1997 - 2002 Corvette: Service Bulletin: SMU - Revised Side Cover and Gasket Replacement (RH)/Differential Carrier Cover and Seal Replacement

Number: 02-04-20-003

Subject: SMU - Revised Side Cover and Gasket Replacement (RH)/Differential Carrier Cover and Seal Replacement - Right

Model Year: 1997-2002 Chevrolet Corvette

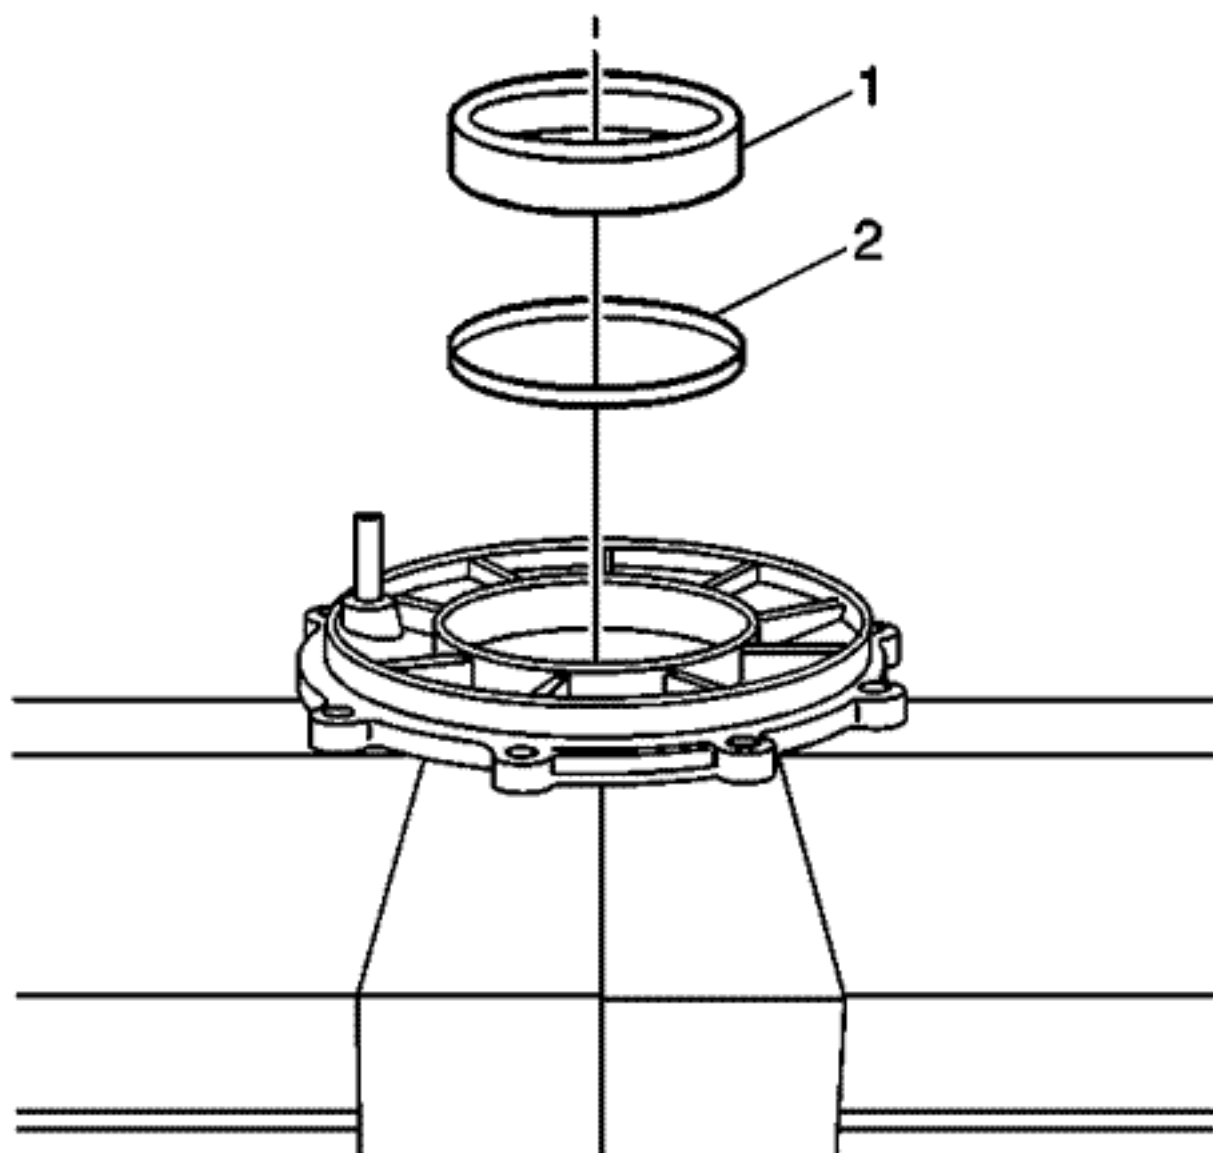
Whenever service requires the replacement of the right side differential cover, the covers **MUST be measured and the right side shim pack adjusted to compensate for machining tolerances between the two components. Failure to perform this measurement procedure may result in improper differential bearing preload.**

13. Use a caliper (2), a straight edge (1), and J 42168-16 (3) in order to measure the NEW differential cover bore dimension. Record the measurement as value A.
14. Use a caliper (2), a straight edge (1), and J 42168-16 (3) in order to measure the old differential cover bore dimension. Record the measurement as value B.
15. Subtract value B from value A. If the computation is a positive value, add shims equal to the value, to the existing shim pack. If the computation is a negative value, subtract shims equal to the value, from the existing shim pack.
